# Access Compliance Report

## Public Rights-of-Way

Intersection ID: 14504	Main Street: E_7TH_ST	Cross Street: CAMERON_AV	Location: SW
ADA ID: DE26F9669015	Ramp Type: PerpDiag	Initial Pass/Fail: Fail	Overall Compliance: No
Codes/Mitigation Info/Possible Solution		Field Measurements/Component Compliance

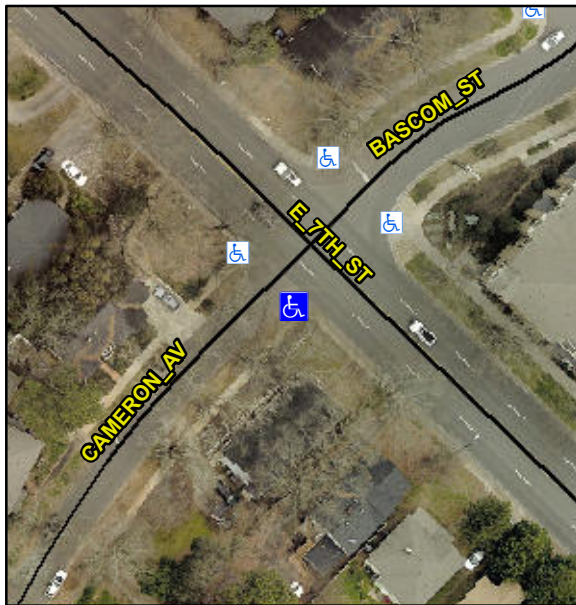
**Not Found, R304.5.1, R304.2.2**

Compliance	Description	Data	Compliance	Description	Data
N/A	Ramp Length (in)	69.0	No	Ramp Slope (%)	8.6
No	Ramp Width (in)	40.5	Yes	Ramp XSlope (%)	0.7
N/A	Flare Type LT	N/A	N/A	Flare Type RT	N/A
N/A	Flare Slope LT (%)	N/A	N/A	Flare Slope RT (%)	N/A
N/A	Flare Traversable LT?	N/A	N/A	Flare Traversable RT?	N/A
N/A	Landing Length (in)	N/A	N/A	DWS Provided?	N/A
N/A	Landing Width (in)	N/A	N/A	DWS Contrast?	N/A
N/A	Landing Slope (%)	N/A	N/A	DWS Length (in)	N/A
N/A	Landing X Slope (%)	N/A	N/A	DWS Full Width?	N/A
N/A	Landing Curb? (Y/N)	N/A	N/A	DWS Offset (in)	N/A
N/A	Shared Landing?	N/A			
N/A	Gutter Ponding?	N/A	N/A	Gutter Slope (%)	N/A
N/A	Gutter Lip Ht (in)	N/A	N/A	Gutter X Slope (%)	N/A
N/A	Painted X Walk1?	No	N/A	Painted X Walk2?	No
	X Walk 1 Direction	To NE		X Walk 2 Direction	To NW
N/A	X Walk 1 Width (in)	N/A	N/A	X Walk 2 Width (in)	N/A
	X Walk 1 Slope (%)	4.8		X Walk 2 Slope (%)	3.1
	X Walk 1 X Slope (%)	3.8		X Walk 2 X Slope (%)	3.0

**Remove & Replace Curb Ramp With Two New Directional Ramps or Equivalent.**
